# TOWN OF DAVIE

## TOWN COUNCIL AGENDA REPORT

**SUBJECT:** Site Plan, SP 2-6-03 Village Parc Townhomes, Jose R. Merlo/Davie Road, LLC, 7901 Davie Road Extension/Generally located 500' east of the northeast corner of University Drive and Davie Road Extension

**TOWN OF DAVIE**  
**Development Services Department**  
**Planning and Zoning Division Staff**  
**Report and Recommendation**

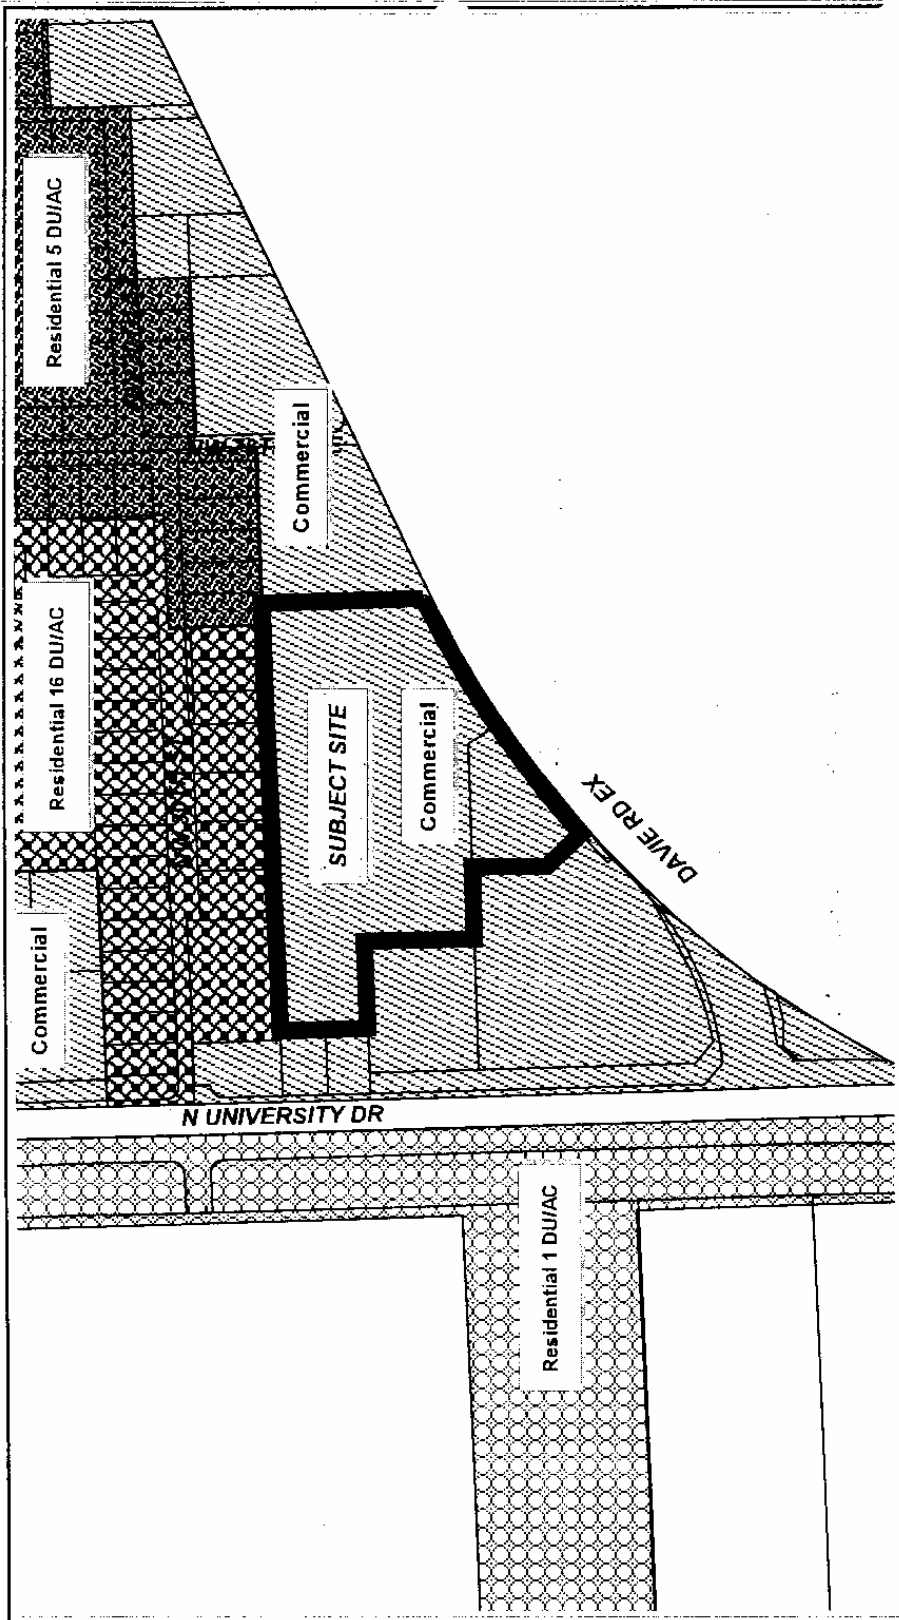
1. The sidewalk exiting the development needs to be linked with the existing sidewalk that runs along Davie Road.
2. There needs to be a sidewalk on the east side of the entrance way, around the bend and long enough to allow a crossing from the sidewalk at Building 5, and to hook up with the existing sidewalk on Davie Road Extension.
3. Mark pedestrian crossings in the road which lead to the community facility areas.

4. After relocating the dry retention area and making a park there instead, elaborate on the park facilities with benches and picnic tables.
5. Relocate existing trees to permanent location just one time.

6. Substitute Ligustrum trees next to buildings with Triple Alexandra Palms or equivalent Palms, minimum 12 to 14-foot height.
7. Work with the Town's Urban Forester Mike Orfanedes on his comments regarding setbacks of trees from structures and hard surfaces (substituting Palms for trees that won't work for his comments); however, make sure the minimum requirement for canopy trees is met. If applicant cannot meet the minimum requirement for canopy trees by the buildings, canopy trees could be added to the top of dry retention areas.

8. Add small canopy trees between the redesigned driveways (new seven-foot openings).
9. Coordinate tree relocation with the installation of the dry retention areas so that the trees will be relocated one time.

10. Negotiate the Green Buttonwood trees and Yellow Tabs for possible mitigation. The emphasis should be on the large Live Oak trees to be relocated and the other trees could be mitigated.

11. Provide detailed plans for pool, deck area and bath houses.
12. That the parking in front of the units should be an 18-foot paved area, eliminate the two-foot space between the side-to-side garages, and increase the green area (now every four parking spaces) to approximately seven feet.

13. Reduce the amount of covered entry and increase that green area.
14. Have vertical and horizontal banding continued on rear elevations of buildings as indicated on sheet A-12.

15. Look into possibly eliminating the covered patio in the back of the "B" and "C" units and make that area interior space.
16. Remove the artist's "shading" from the drawings of windows on the plans so that the reader could see what the windows look like.

17. Since the east most entrance will be reduced from four lanes to three lanes, add the extra space to the median island by making it shorter and wider.

18. Provide a photometric plan which includes details on the site lighting poles, fixtures and their locations.
19. Provide postal delivery information.

1. That the pedestrian crossways at the community facilities be concrete pavers.
2. That the park area by the cabana would be shown with the benches and picnic tables.
3. That the applicant would correct LS-1 and ST-1 to match the site plan.
4. That the relocation of existing trees be discussed with the Town's Urban Forester Mike Orfanedes for his opinion on whether they would be moved to good locations.
5. That items 6, 7, 9 and 10 remain to be left to the direction of Mr. Orfanedes.
6. That the pool house needs corrections and needs a larger plan showing the bathrooms; take out the planters and have a five-foot wall with plantings on the inside at the pool deck area as well as landscaping on the outside of the wall.

7. Label the roof material on the plans.
  8. That the parking in front of the units should be labeled 18-foot wide driveways thereby eliminating the compact indication in the spaces in front of the units; make an 18-foot paved area and increase the green area between those driveways; and then look into whether or not a tree could be placed in the larger green area.

9. Put in the vertical banding on the unit's rear elevations which would be at the unit separations.
  10. Provide a photometric plan; make certain that SP-2 and DO-2 match; show the lighting poles and their locations; if base protection was needed because no protective curbing was by the light poles, a poured concrete base may be needed to which the light pole would be mounted.

11. Postal delivery was recommended to be located at the cabana area in one central pavilion with "pull off" areas off the main drive, if the Post Office approves.
